### **Product Change Notice (PCN)**

PCN Number: PCN-0451317R-01

Product(s) Affected: PD-30S and PD-40S

Reason(s) for Change: Manufacturing build location change

#### **New Design PD-30S**

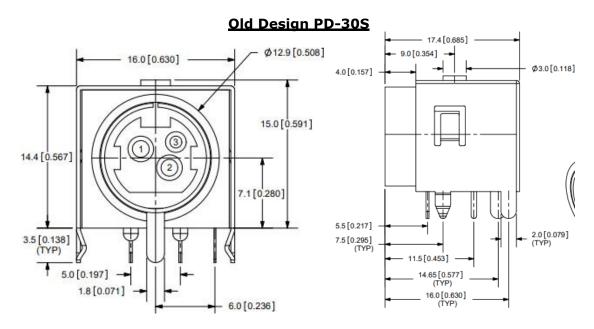
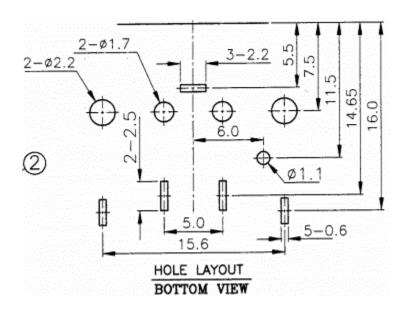
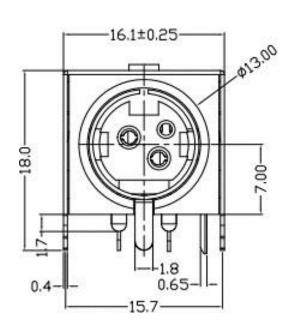
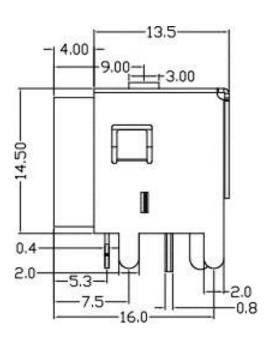
**Description of Change:** Housing, materials, and PCB layout changes as shown below.

MATERIAL	PLATING
TERMINAL 1	Phosphor Bronze	Tin
TERMINALS 2-3	Brass	Tin
EARTH TERMINAL	Brass	Tin
SHIELD	Steel	Tin
HOUSING	PBT

MATERIAL	PLATING
housing	PBT (UL94V-0)	
contact	phoshor bronze	silver
ground	brass	nickel
shell	SPCC	tin

#### **New Design PD-40S**

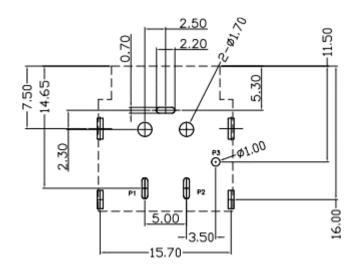
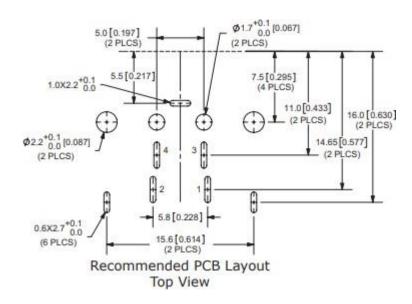
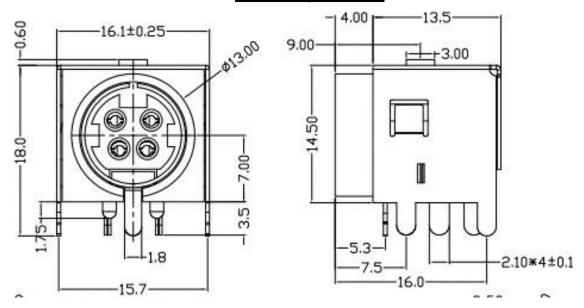
MATERIAL	PLATING
terminal 1	brass	tin
terminal 2	brass	tin
terminal 3	brass	tin
terminal 4	brass	tin
earth terminal	brass	tin
shield	steel	tin
plastic	PBT

MATERIAL	PLATING
housing	PBT (UL94V-0)	
contact	phoshor bronze	silver
ground	brass	nickel
shell	SPCC	tin
